MAP Series of PWR Fuel Assembly Packages

NRC Meeting – September 24, 2007

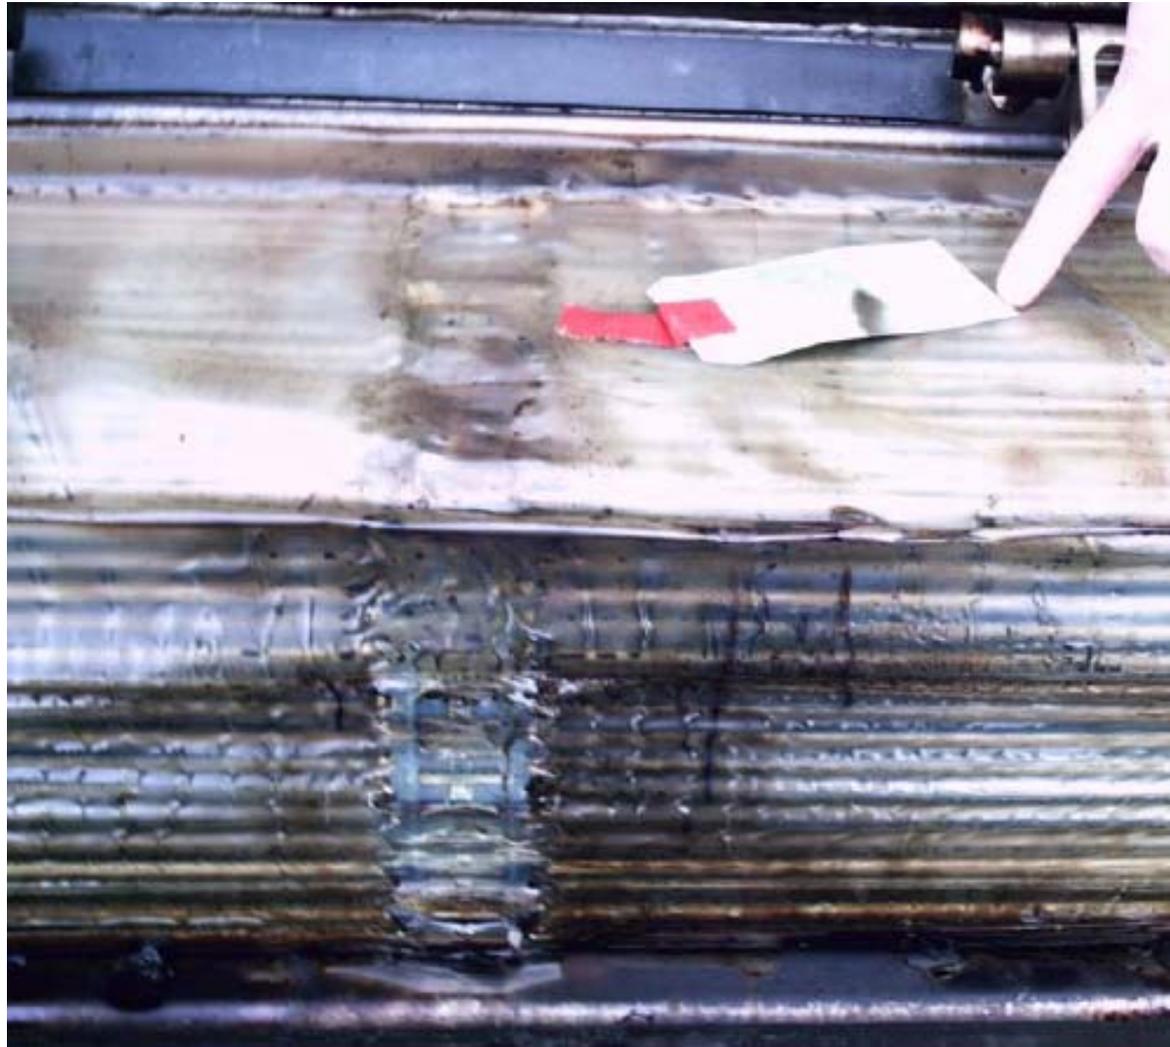
- ◆ Provide a detailed description of the temperature sensitive strips used during thermal testing and a rationale for their use over other methods of measuring temperatures inside the package during the HAC fire test. Provide additional justification for the accuracy of predicted temperatures for components internal to the package.
- ◆ Section 3.4.3.1, page 3-23, of the SAR states that temperatures inside the package were to be measured with temperature sensitive strips, which were unreadable due to condensation from foam out-gassing, causing the temperatures to be estimated from the extent of damage to each package component. Given this, temperature sensitive strips appear to be a less than ideal choice for this application. The temperatures reported in the SAR need to be more accurate in order to make a safety finding.

- ◆ Temperature indicating strips were Tempil Thermax THE06S-8. Temperature indicating strips were used because the expected peak temperature inside package was relatively low, use of thermocouples would require altering package to route leads. CTU's dropped prior to fire test, no way of protecting T/C leads extending beyond surface of package without risking integrity of drop test results - protective covers required for leads. Adding T/C's after drop tests was not an option as packages could not be opened/re-closed to post-drop configuration.

- ◆ Estimating peak temperatures attained in a fire based on condition of components. The fuel assembly has an accident temperature limit of 1,058°F (570°C) or higher, whereas polyethylene wrap surrounding the fuel assembly has a melting point of 230 to 275 °F. Given that polyethylene wrap was essentially un-damaged and the large thermal margin between 1,058°F and 275 °F, the accuracy of the predicted temperatures is deemed sufficient to assess the safety of package design.

- ▶ **Nylon 6,6 emerging worst case melted section in lid**

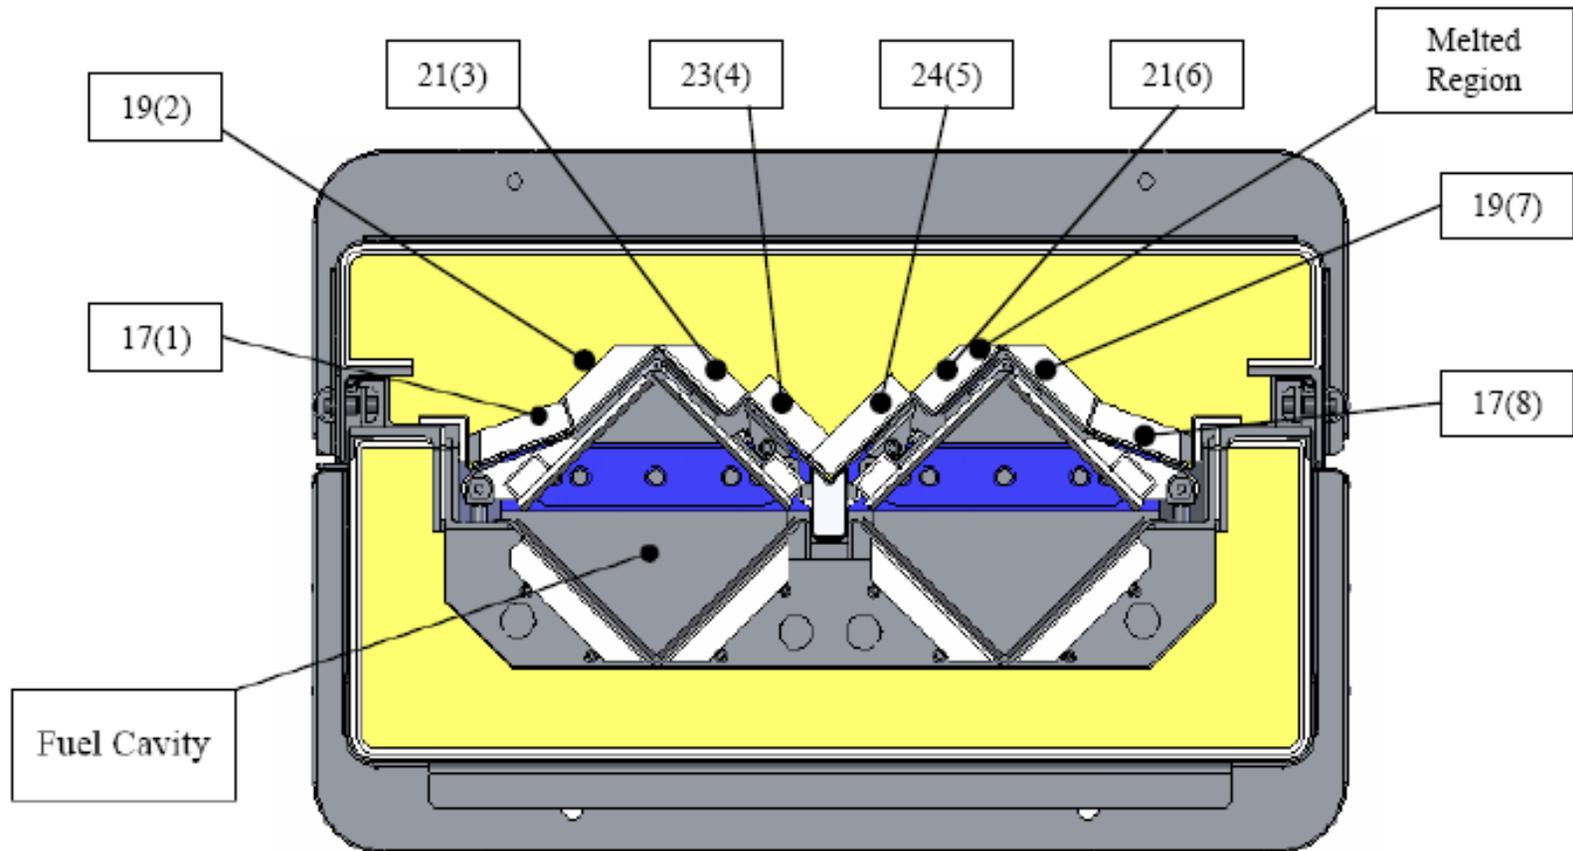
- ◆ **Provide a complete description of the physical state of the neutron moderator components after the HAC fire test. Include photographs of those components if available (reference Section 3.4.3.1 of the SAR).**
- ◆ **One of the criteria by which the package design is to be evaluated is how the neutron moderator components survive the HAC fire test. Therefore, the staff requires all possible information relating to their condition after the fire.**

- ◆ **Additional pictures and data table will be added to the SAR.**

- ▶ **Polyethylene wrap removed after drop and fire test
CTU3– no bent or damaged rods**

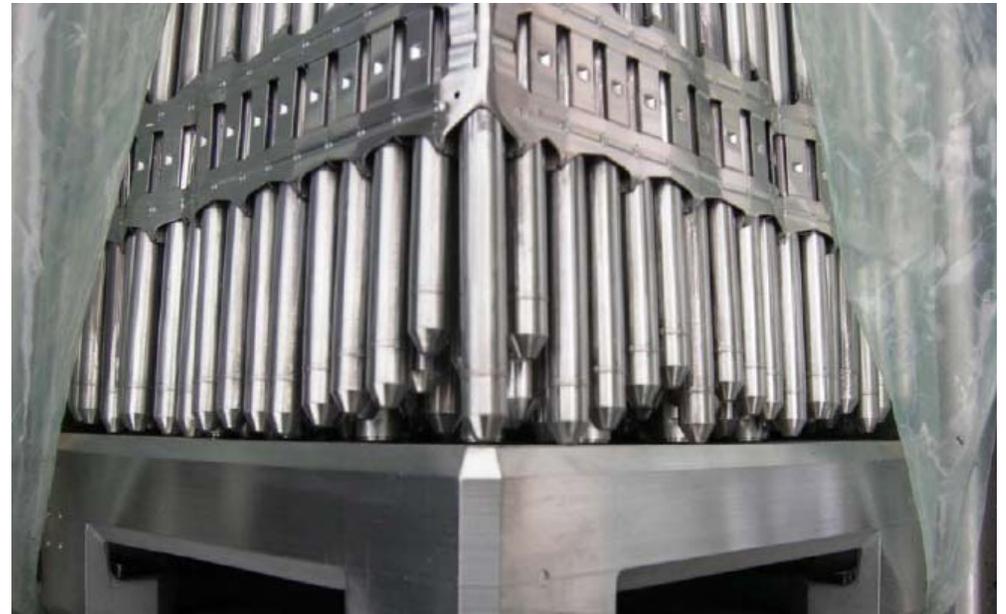
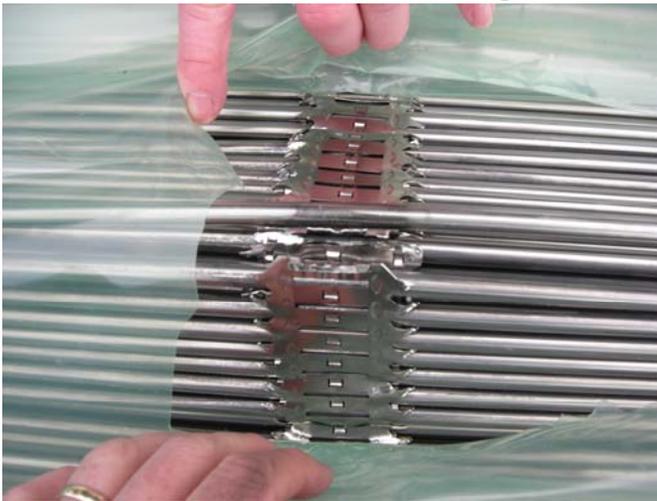
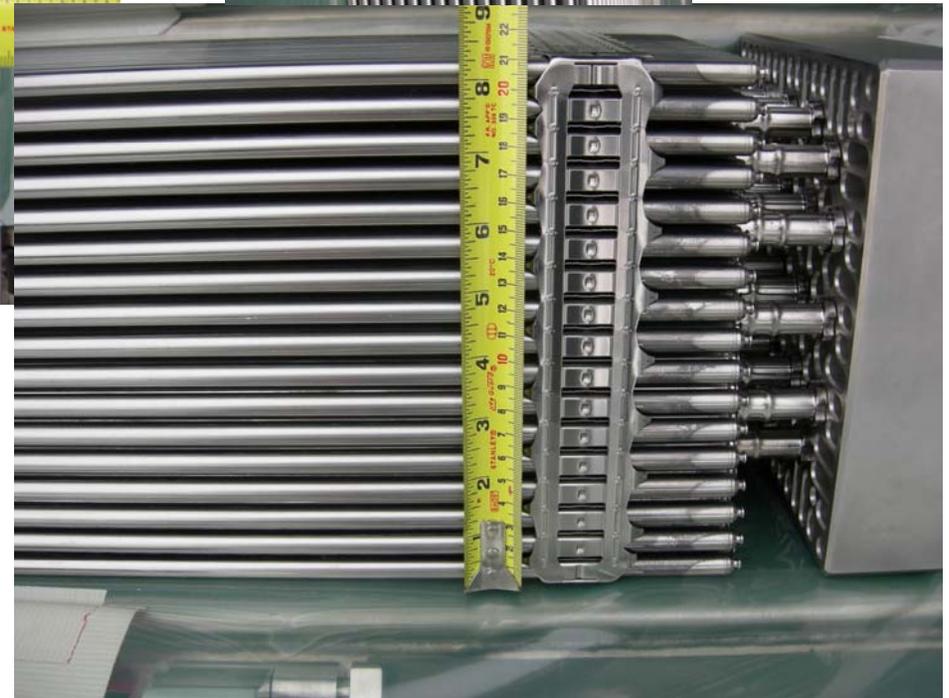
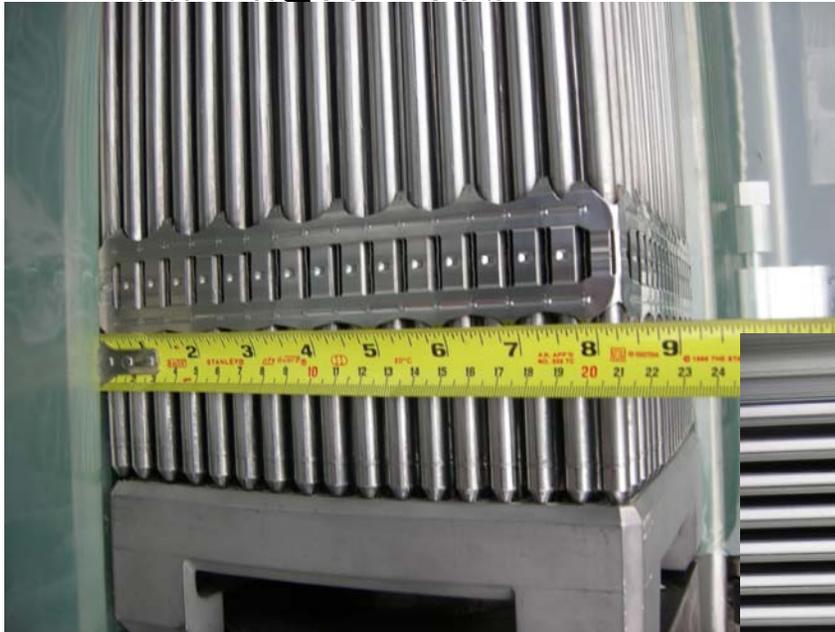
- ◆ Provide justification in the SAR that the cladding can withstand HAC in the form of drop test and fire test results, such that the containment boundary remains unbreached. Also, describe the condition of the cladding after being subjected to HAC.
- ◆ Section 4.3.2.2 states: "The performance tests documented in Section 2 [of the SARI demonstrates that no pellets are released from the cladding as a result of the postulated hypothetical accident conditions." Contrary to this statement no material could be identified in the SAR that describes the condition of the cladding after being subjected to HAC.

- ◆ Section 2 will be revised to include a description of the cladding following the drop and fire tests:
- ◆ A visual inspection of the fuel rods in the CTU did not identify any bent or damaged rods. Test assemblies were removed from CTU and further inspected, and no cracked or breached rods were identified visually. Random sample of rods was removed from most damaged assembly and checked for pressurization. All were pressurized. No leakage or breach of rods occurred as a result of performance tests. Interior of package coated with tars as a result of condensation of foam off-gas; fuel rods, being covered by a thin sheet of polyethylene, remained in their as fabricated bright condition. The HAC fire test had no further effect on cladding.

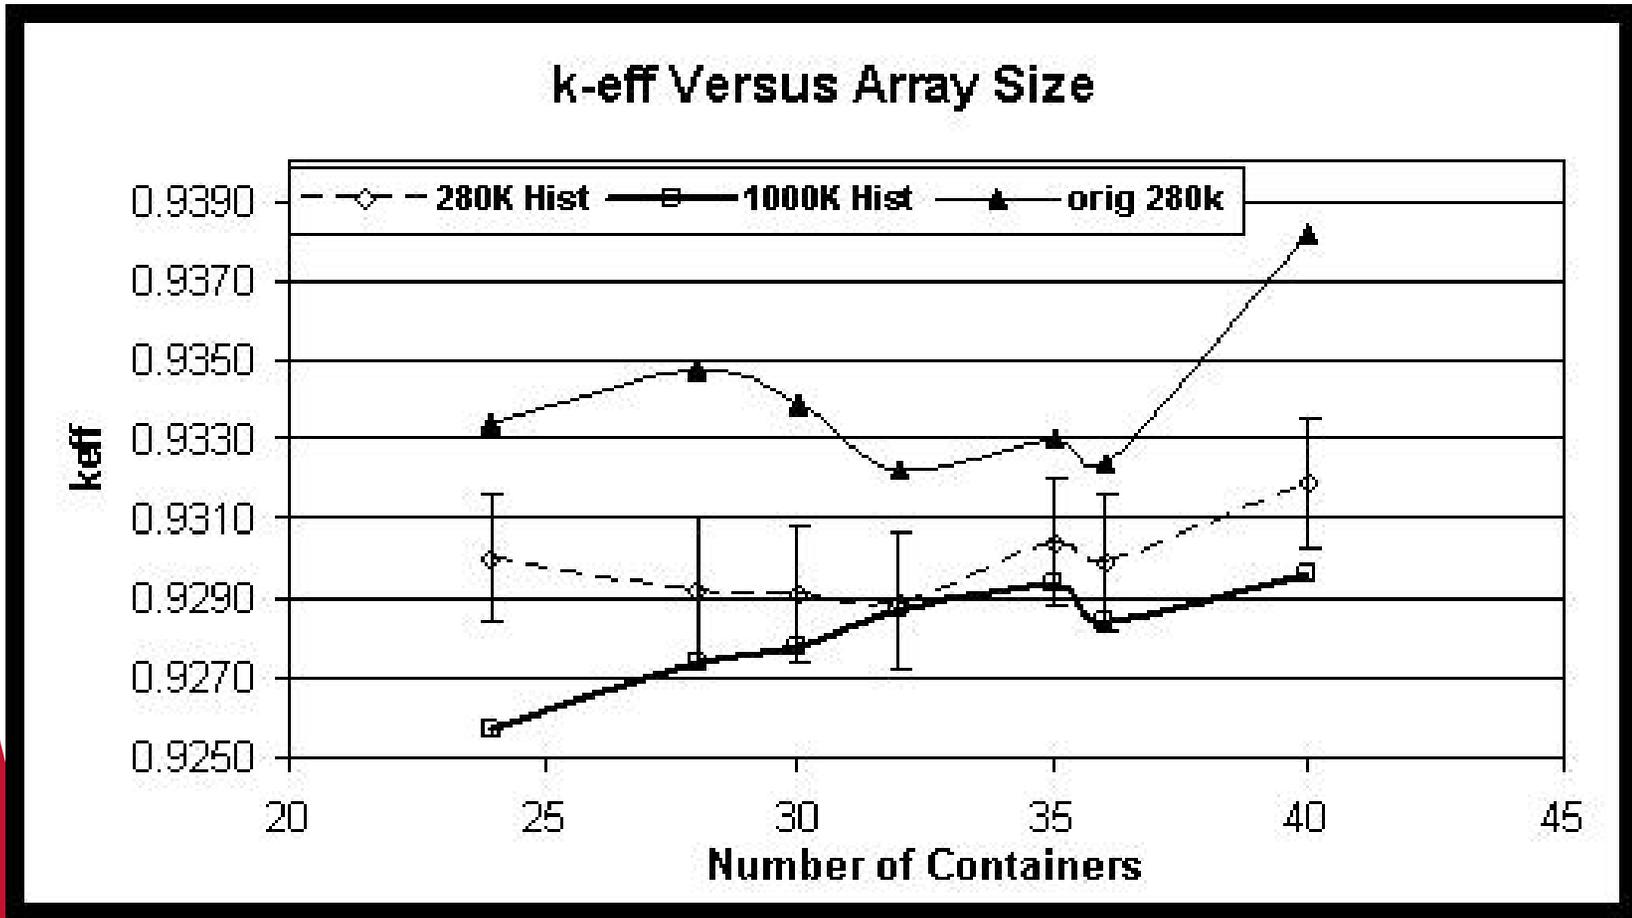
- ◆ **Provide an explanation on the behavior of the keff curves as a function of the package array size, in Figure 6-29.**
- ◆ **Figure 6-29 shows the change of keff as a function of package array size with the FLIP1 configuration. From this figure, it can be observed that the keff value increases first, and then goes down as the number of packages increases. Finally, the keff value jumps from 0.9356 to almost 0.9420. This curve does not seem to be consistent with common understanding of the physics of a fissile system.**

- ◆ **Package array variation, statistics and small span on the keff axes exaggerates trend. Rerunning cases supporting the figure with 280K (UNIX) and 1000K (PC) histories shows more uniform trend (280K). Case with 1000K histories indicates an easily explained trend and illustrates that while smaller number of histories provided conservative values, trend is not quite right. However, both sets are generally within statistical uncertainty. Correct trend observed and the comment easily resolved as due to statistical uncertainty for PC with 1000K histories.**
